STAFF REPORT
COMMUNITY DEVELOPMENT DEPARTMENT

SUBJECT: Springday Subdivision No. 2
FP-2026-0026

LOCATION: 5220 W. Ustick Rd.
Generally located on the north side of W. Ustick Rd., 1/4 mile west of N. Black Cat Rd., in the SE 1/4 of Section 33., T.4N., R.1W.

Final plat consisting of 51 building lots and 8 common lots on 10.49 acres of land in the R-8 zoning district for the second phase of Springday Subdivision.

FINAL PLAT OF SPRINGDAY SUBDIVISION NO. 2

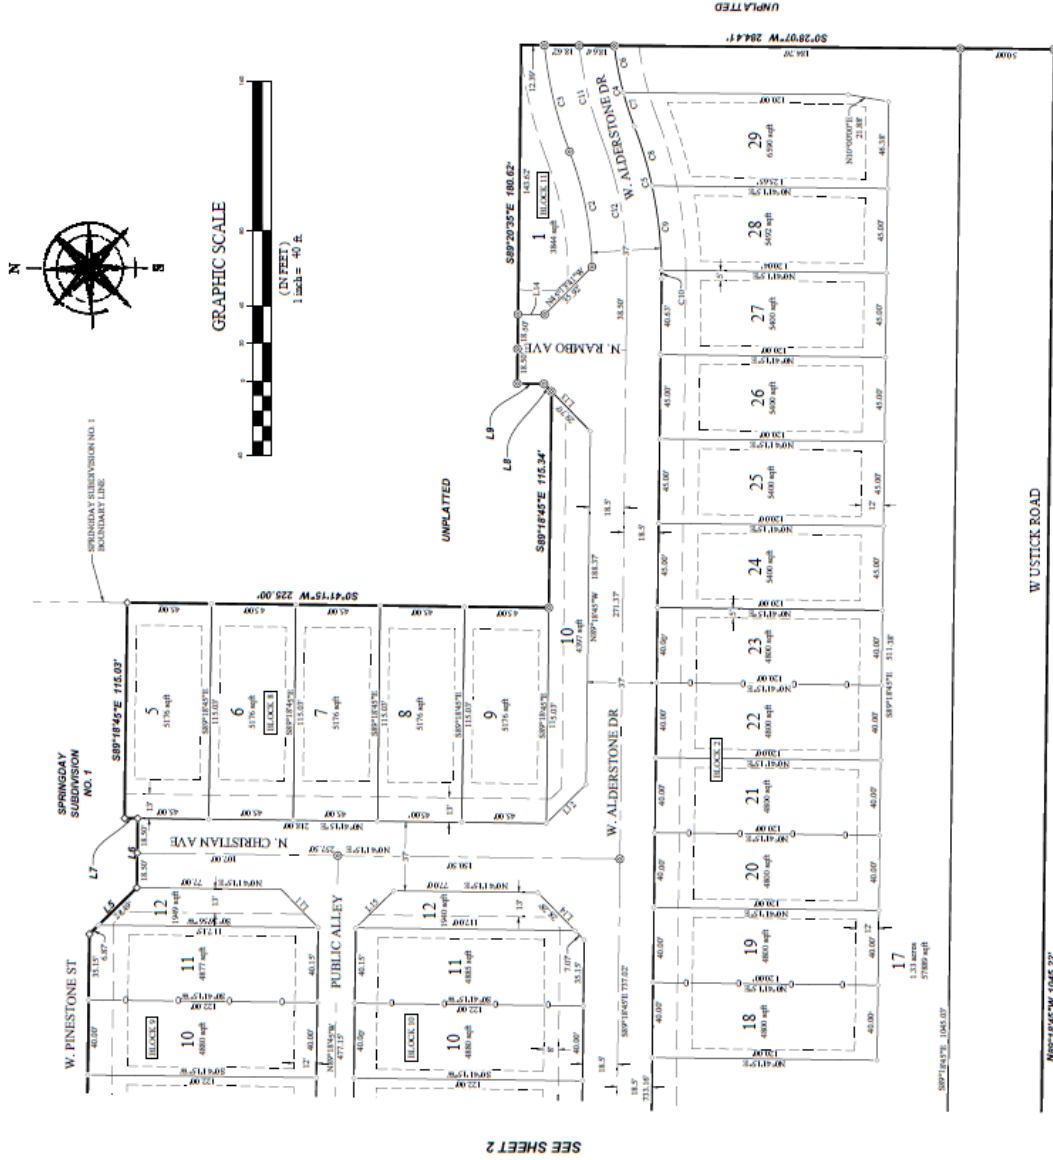
3. Prior to submittal for the City Engineer's signature, have the Certificate of Owners and the accompanying acknowledgement signed and notarized.
4. The final plat prepared by Focus Engineering and Surveying, LLC, dated: 07/29/2026, included in Section V.B shall be revised as follows:

- a. In the Legend, include the recorded instrument number of the ACHD permanent easement.
 - b. Include the CP&F numbers on Sheet 1 at the northwest and southwest corners of the site.

- c. Note #11: Include the recorded instrument number of the ACHD temporary license agreement.

A copy of the revised plat shall be submitted with the Final Plat Mylar application for City Engineer signature.

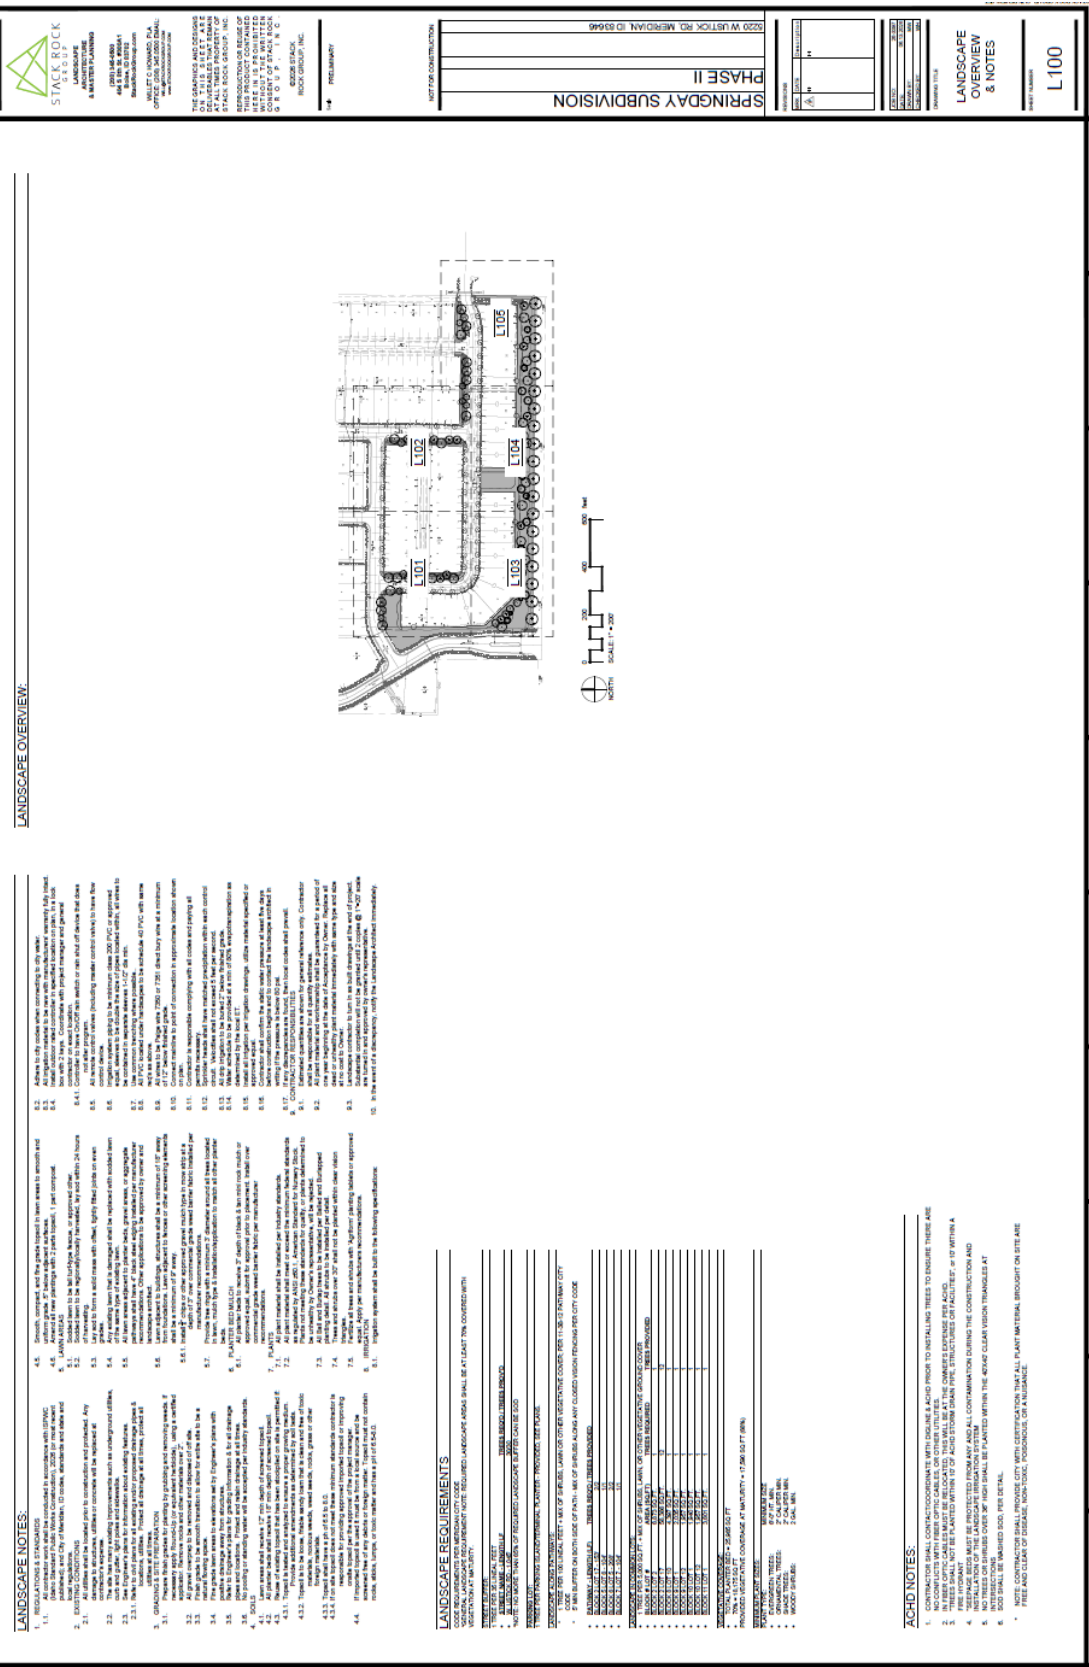
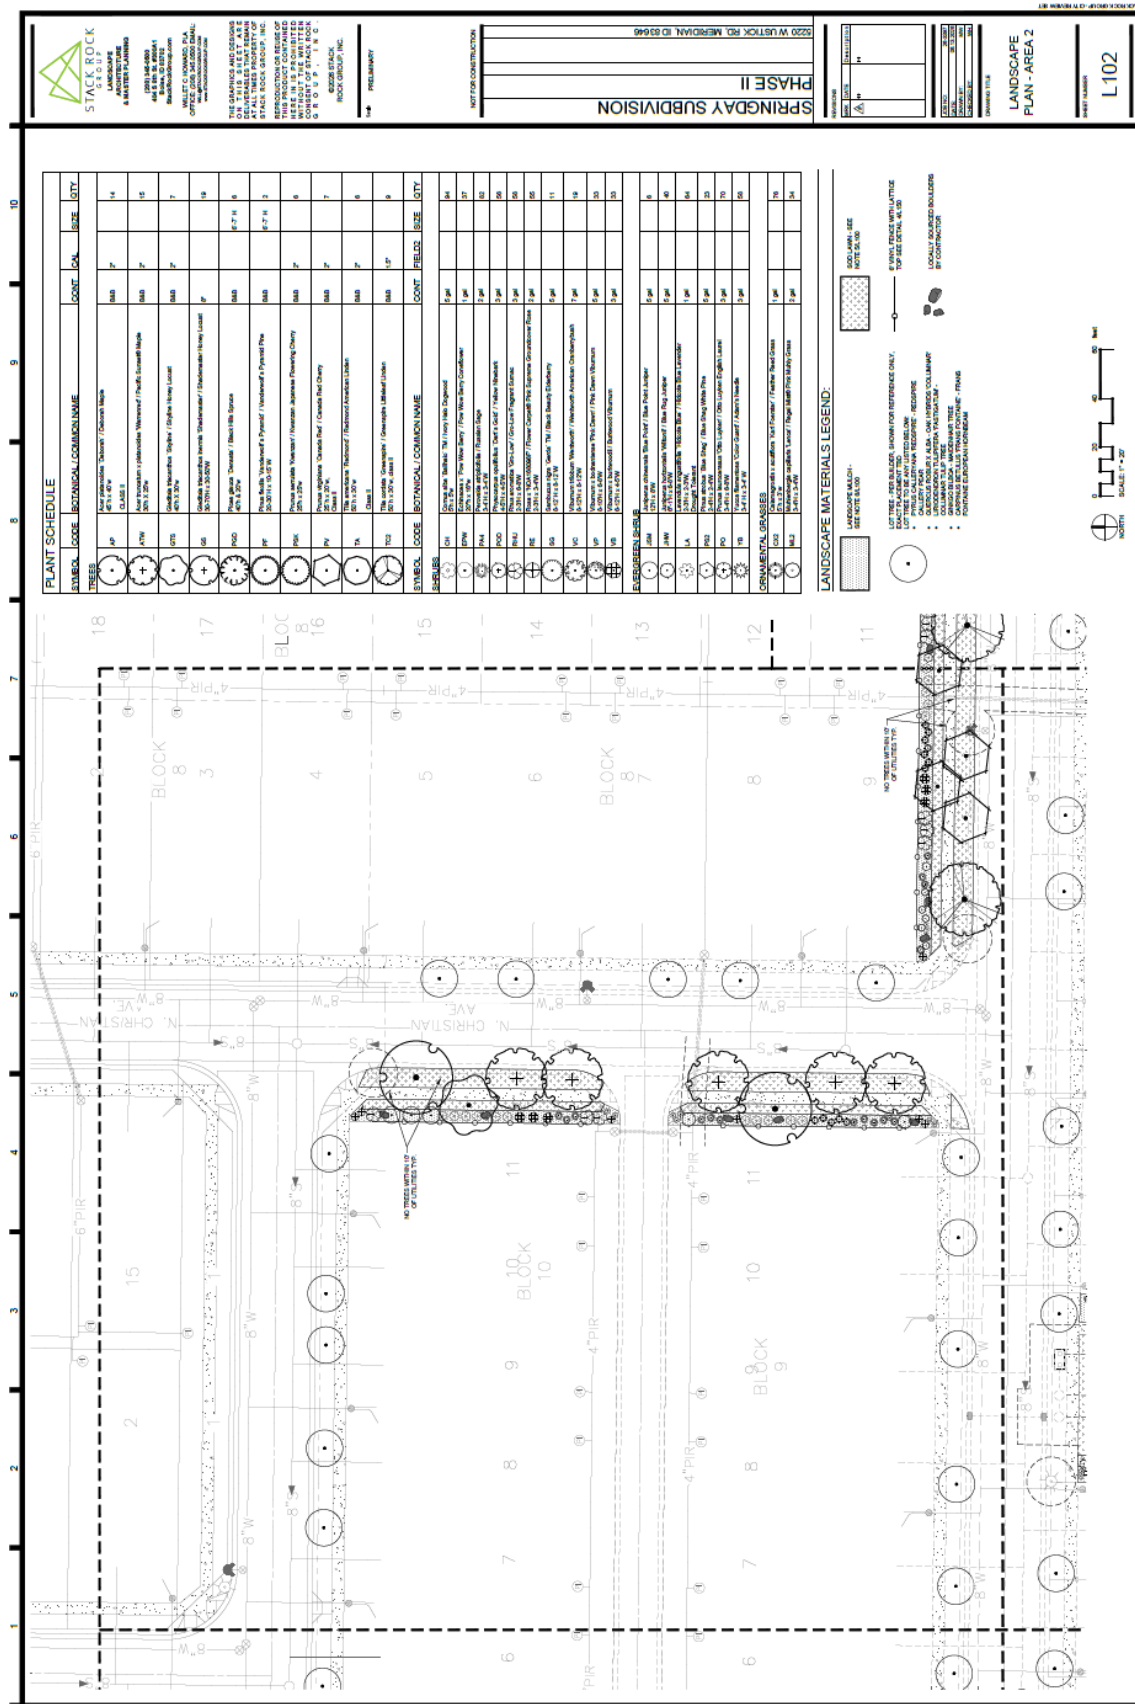
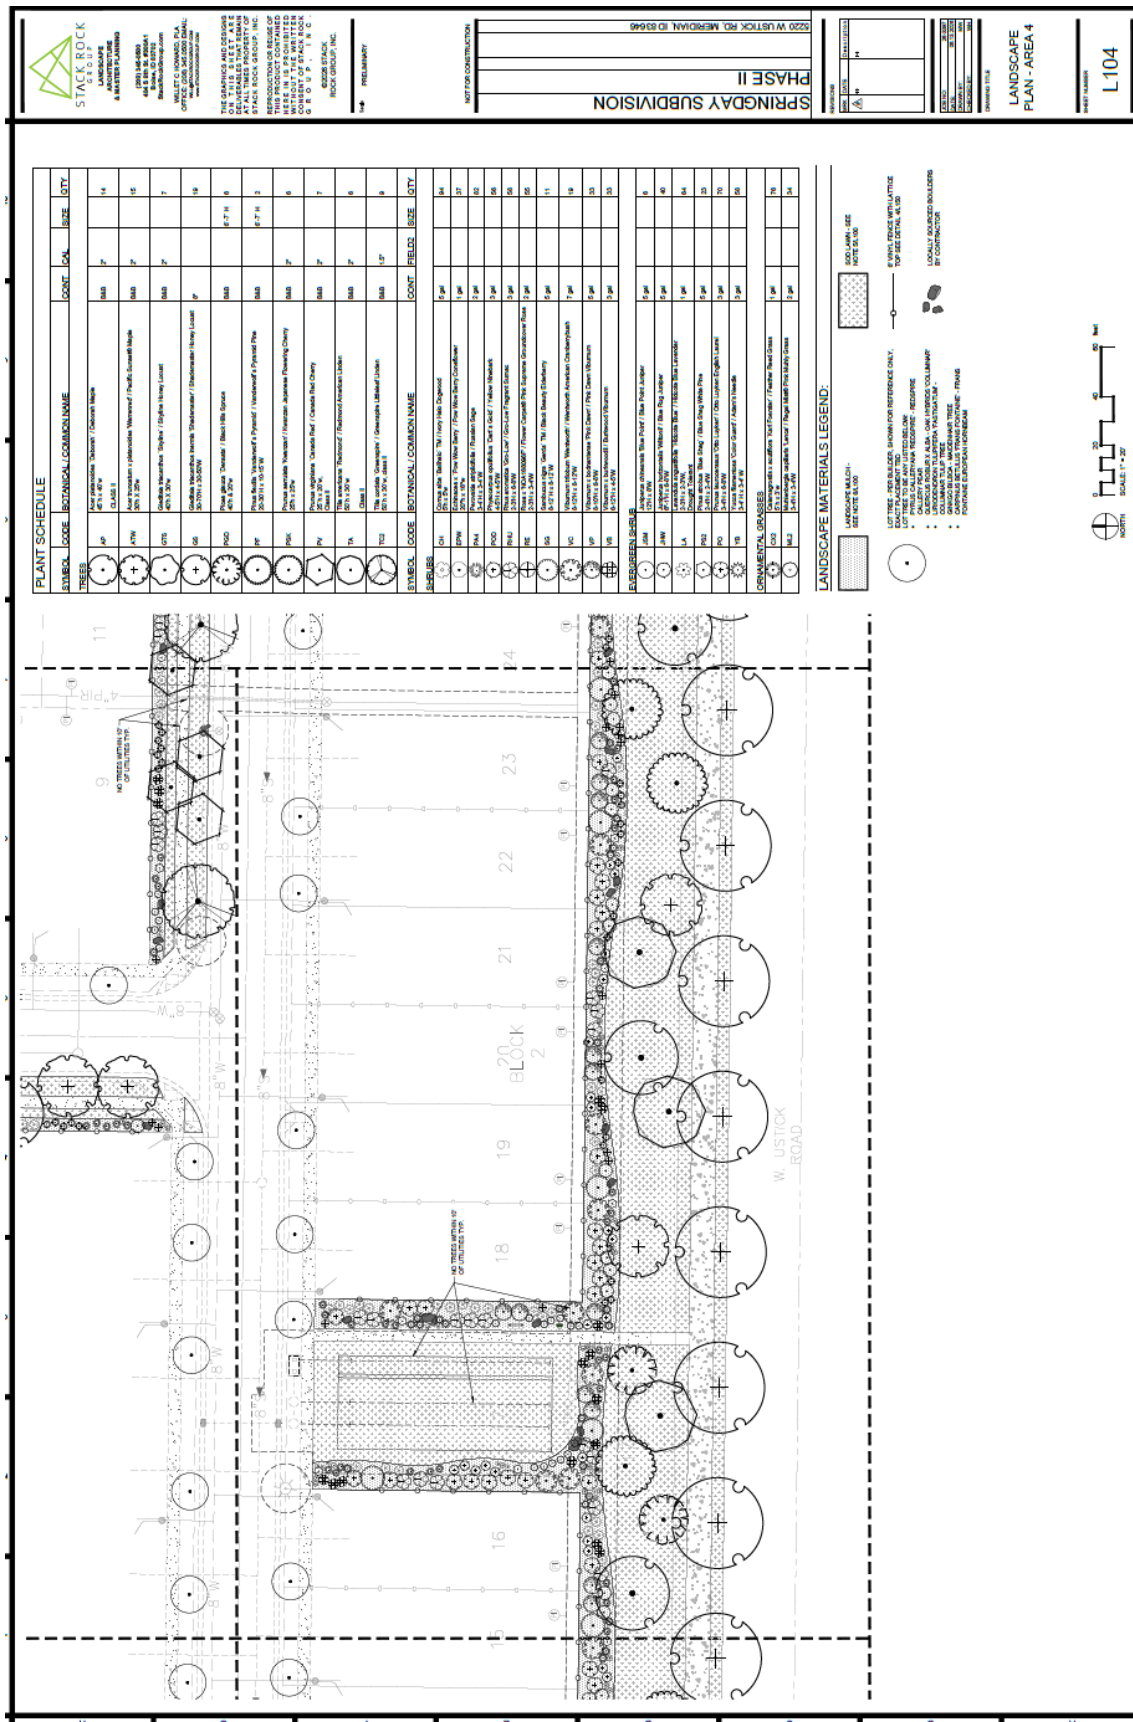
5. The landscape plan prepared by Stack Rock Group, dated 06/13/2026, included in Section V.C, shall be revised as follows:
 - a. Depict a gate or bollards to restrict access to the emergency access driveway via W. Ustick Rd. as determined by the Fire Dept.

- b. Include mitigation calculations in accord with the standards listed in UDC 11-3B-10C.5. The Applicant should contact the City Arborist (Kyle Yorita 208-409-1601) to schedule an inspection prior to removal of any trees from the site.

- c. Depict a minimum of one (1) tree per 100 linear feet along the pathway on Lot 17, Block 2 along the east boundary of the site in accord with UDC 11-3B-12C.

- d. Depict a minimum of one (1) shrub per seven (7) linear feet of frontage along the fence at the back edge of the street buffer along Ustick Rd. in accord with UDC 11-3B-7C.3f; include calculations that demonstrate compliance with the minimum standards.

- e. Depict additional landscape design features within the street buffer along W. Ustick Rd., designated as an entryway corridor per the standards in UDC 11-3B-7C.3f. *Features may include berms of no less than four to one (4:1) slope to at a three-foot minimum height, decorative landscape walls (no greater than three (3) feet in height), decorative open vision fencing (no greater than four (4) feet in height), or design elements with a similar level of effort (Example: a dry creek design with river rock, boulders, etc.).*
